**N1996A-01B**

## Agilent CSA Spectrum Analyzer, N1996A

### Residual Responses due to Shield Problem on A4 Digital IF Assembly

Figure 1: Marker Reading Peak Residual Level

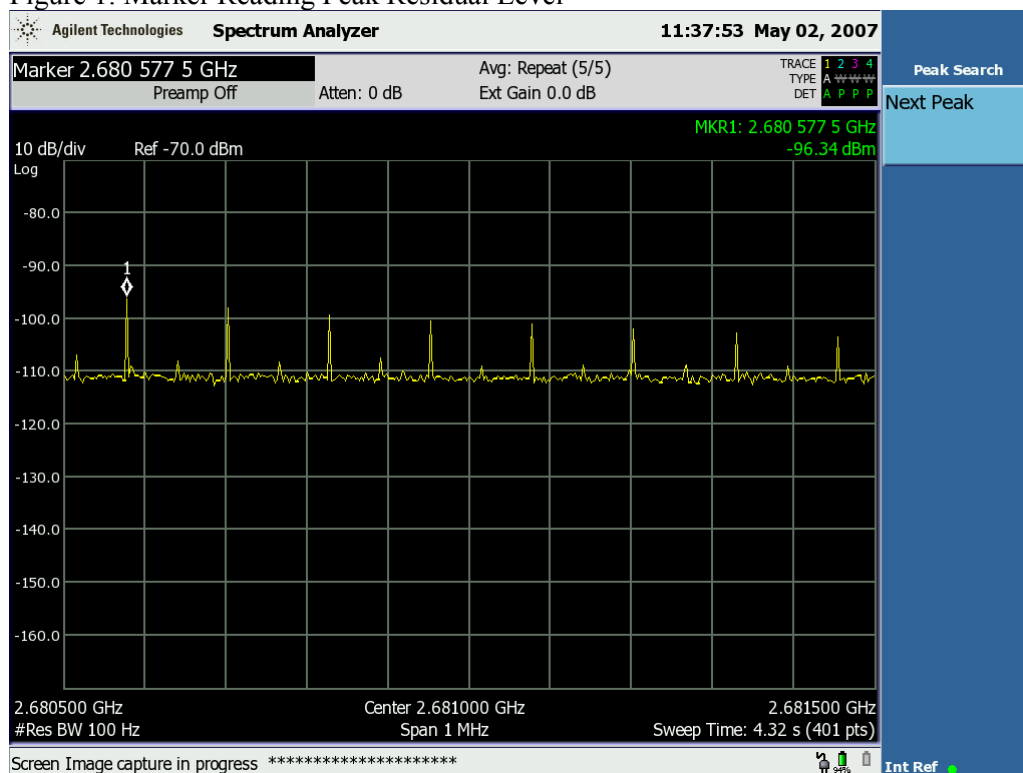
13. If the Peak Residual Level is above -97.7 dBm, the residual responses are too high. Proceed with Solution/Action.
